SUBJECT: Submits info re meteorological sys, in response to NRC informal questions. Dual source power supplies will be provided to both primary & backup towers. FSAR will be revised in mid-Sept. Diagram of primary tower encl.

SUSQUEHANNA STEAM Electric STATION
UPGRADED METEROLOGICAL SYSTEM
ER100450 FILE 841-2
PLA-849

The following information is in response to the Staff's informal questions regarding the meterological system.

Upgraded Meteorological System

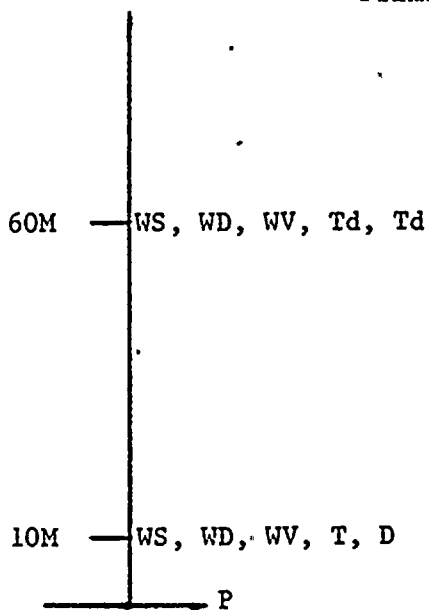
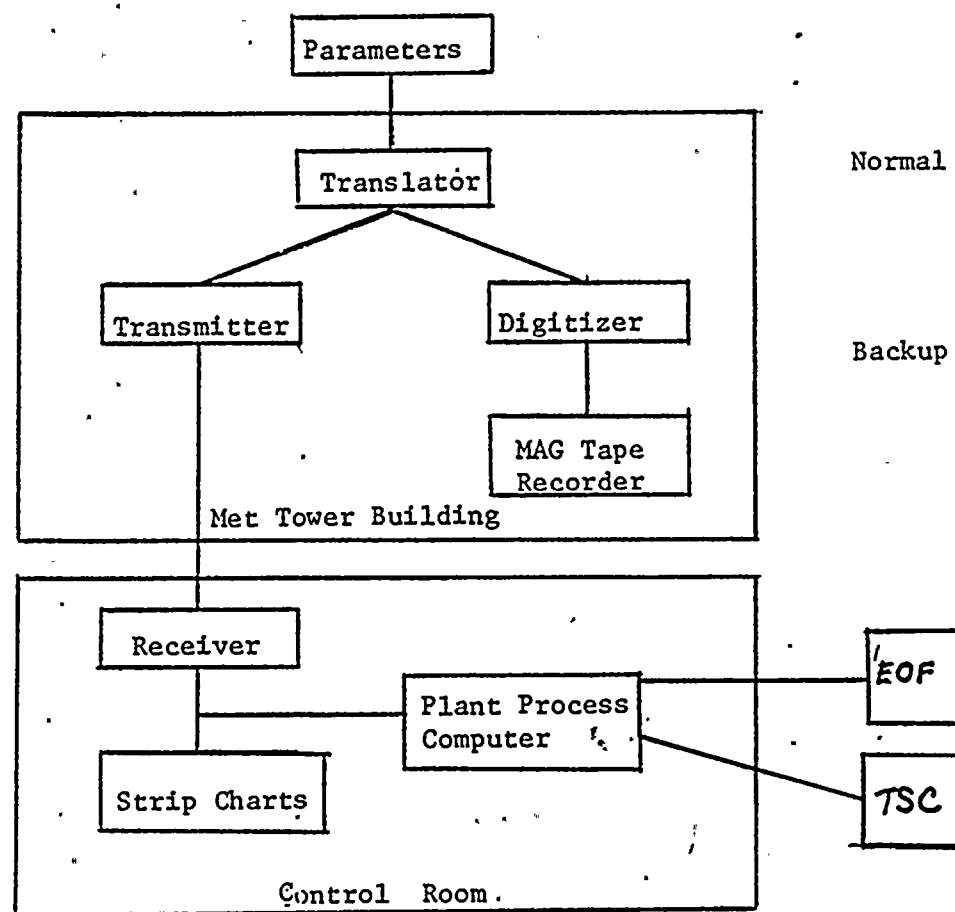
1. Based on the requirements of NUREG-0654 Appendix 2 and proposed Revision 1 to Regulatory Guide 1.23, the attached diagram outlines the upgraded meterological system using the existing meterological tower. Except for the addition of a tipping-bucket rain gauge, all the instrumentation on the primary tower will be as described in the FSAR. In addition, a backup 10 meter pole will be provided (the location is being evaluated) with sufficient instrumentation to measure wind speed, wind direction and sigma θ . These parameters will be available in the control room on strip charts and the TSC and EOF through the plant process computer.

2. Dual source power supplies will be provided to both the primary and backup towers. A two-hour uninterruptible power supply will be provided for the primary tower.
